REVISION

S. B. 9207

Date: 11/16/92

CRACKED DISC RETAINING NUTS
IN
TARGET ROCK CORPORATION
MANUAL AND MOTOR OPERATED VALVES

FIGURE 1

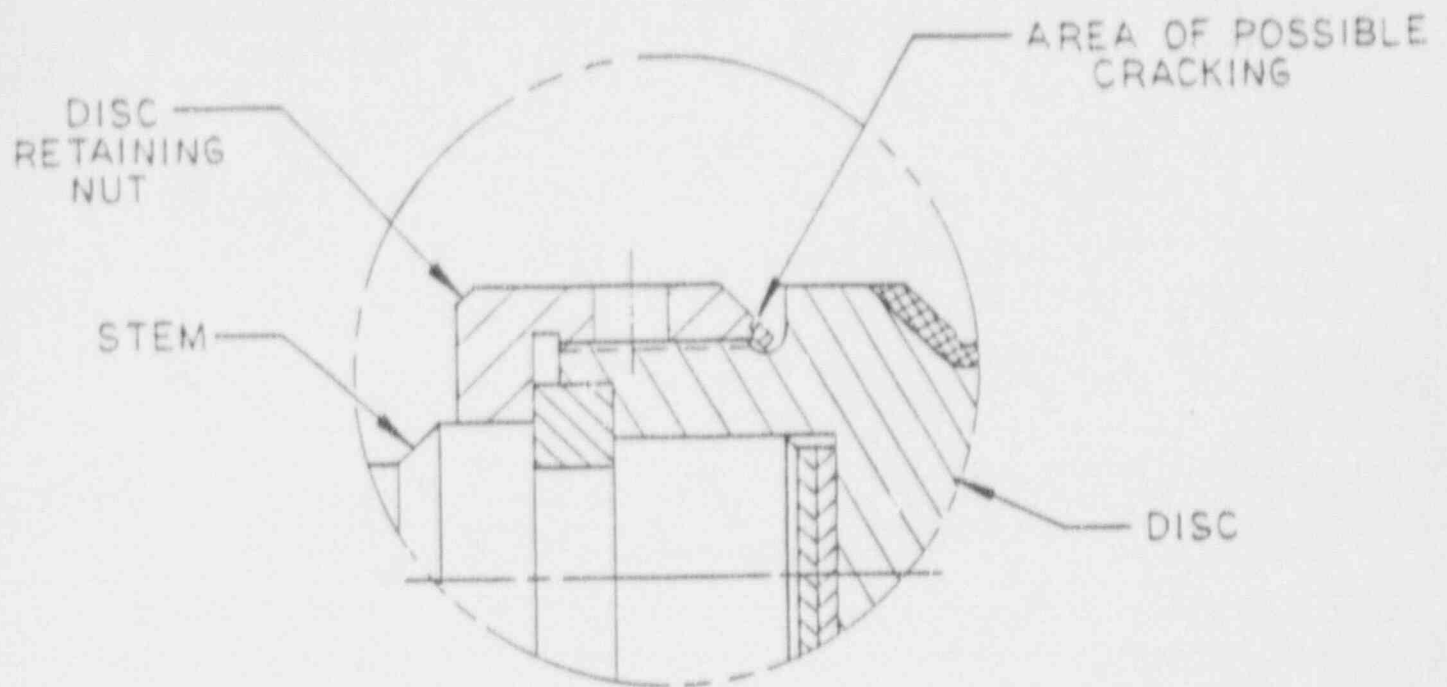
Recently at Arkansas Nuclear One (ANO), a number of 2" valves were found to have a circumferential crack along the edge of the swaged lip of the disc retaining nut (See Figure 1). The cracks were located such that a breakage or loss of the swaged lip could conceivably permit the disc nut to unthread. Should the disc become loose it could render the valve incapable of performing its safety related function.

In the High Pressure Safety Injection (HPSI) Valves at Arkansas Nuclear One (ANO), a heavy load is transmitted through the Disc Nut threads to the disc (and possibly through the swaged member) when the valve is being opened against the full plant system ΔP of 2485 psi. For this 2" valve, a lifting force of over 5000 lbs. could be a primary cause of the crack.
